DETAILED ACTION

Art Unit: 3633

Reproduced from Muller

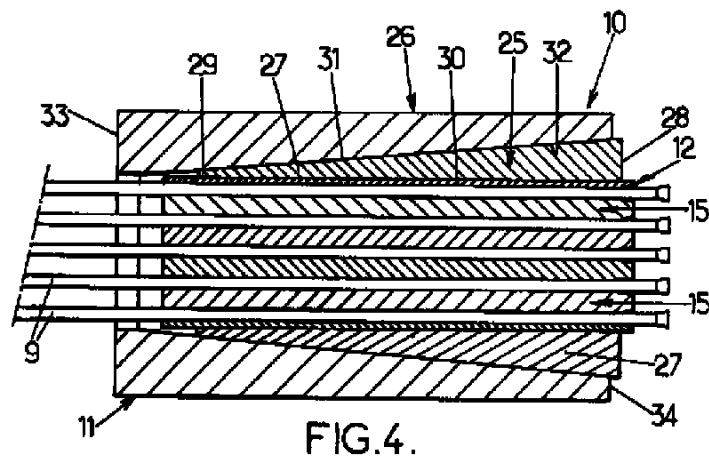
1. Determining the scope and contents of the prior art.
 2. Ascertaining the differences between the prior art and the claims at issue.
 3. Resolving the level of ordinary skill in the pertinent art.
 4. Considering objective evidence present in the application indicating obviousness or nonobviousness.
4. Claims 1, 4, 6, 7, 9, and 17 are rejected under 35 U.S.C. 103(a) as being unpatentable over Muller (DE20302249 – English translation) in view of Stubler et al. (6,487,757) and Sunderland (1,910,269).
5. Regarding claim 1:
- a. Muller discloses a building protection system including:
 - i. Wire cables maintained under tension (40, Fig. 3).
 - ii. The cable ends of a predetermined cross-sectional size and material (40).
 - iii. Clamping bodies that has a guide shaped such that the reaction force of the clamping body increases with an increase in tensile force (42; p. 8, 1-3).

- b. Muller does not expressly disclose that the clamping body guide has a frustoconical surface that narrows progressively in the direction of the tensile force, that the body has a passage receiving the cable end, or that the clamping bodies are made of a harder material than the cable ends.

Reproduced from Stubler

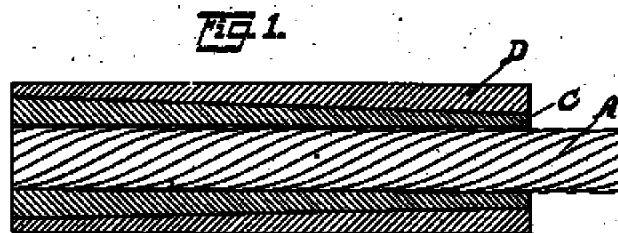
- c. Stubler discloses a system for connecting a cable to a ground structure that includes a clamping body (26, Fig. 4) with a guide (25) having a frustoconical surface that narrows progressively in the direction of the tensile force, and an inner guide surface material that is harder than the wire cable material (Fig. 4).

7. Regarding claim 6, Muller/Stubler/Sunderland as modified above discloses a building protection system with conical clamping body, with Stubler further disclosing a guide comprised of a plurality of clamping jaws mounted at individual mutual angles (25).

9. Regarding claim 9:
 - a. Muller/Stubler/Sunderland as modified above discloses a building protection system with conical clamping body, with Stubler further disclosing multiple cables held by a single sleeve (9, Fig. 4).

10. Regarding claim 17, Muller/Stubler/Sunderland as modified above discloses a building protection system with conical clamping body, with Stubler further disclosing wire cables under tension forming a net structure (40, 46).

Reproduced from Jackson

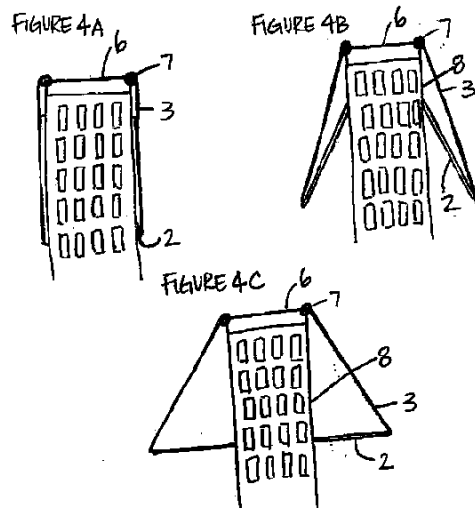
- i. Wire cables maintained under tension (3, Fig. 4).
- ii. The cable ends of a predetermined cross-sectional size and material (3).
- iii. Cables attached to a support beam (2).

b. Jackson does not expressly disclose how the cables are connected to the support beam, and specifically does not mention that the cables are held by clamping bodies having a guide shaped such that the reaction force of the clamping body increases with an increase in tensile force.

disclosing wire cables capable of being accommodated at the roof (3 stored in 7; [0028]).

14. Regarding claim 11, Jackson/Morell/Sunderland as modified above discloses a building protection system with conical clamping body, with the combination further disclosing a frame structure outside the building (6) that offers a surface in which the wire cables can be accommodated (7).

15. Regarding claim 12, Jackson/Morell/Sunderland as modified above discloses a building protection system with conical clamping body, with the combination further disclosing profiles mounted on the roof that form cavities in which wire cables can be accommodated (7).

16. Regarding claim 13, Jackson/Morell/Sunderland as modified above discloses a building protection system with conical clamping body, with the combination further disclosing a clamping body that is translationally movably connected to the building (2; [0028]).

17. Regarding claim 14, Jackson/Morell/Sunderland as modified above discloses a building protection system with conical clamping body, with the combination further disclosing profiles (2) mounted on facades (8) and that can be rotated, swung, or moved translationally (2).

18. Regarding claim 15, Jackson/Morell/Sunderland as modified above discloses a building protection system with conical clamping body, with the combination further disclosing profiles (2) that cause the cables to be pulled out of storage places (7) and be placed under tension.

Reproduced from Morell

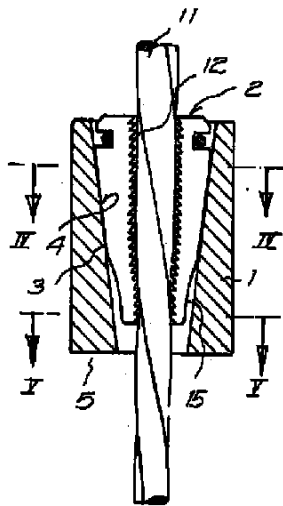
- c. Morell discloses cable gripping/clamping bodies (1, 2, Fig. 2) that have a guide passage (4) receiving the cable end (11 held by 2) and shaped such that the reaction force increases proportional to the tensile force.

- h. The examiner notes that the broadened cable extension of the combination is engaged with the inside surface of the clamping bodies through the wedge 2.
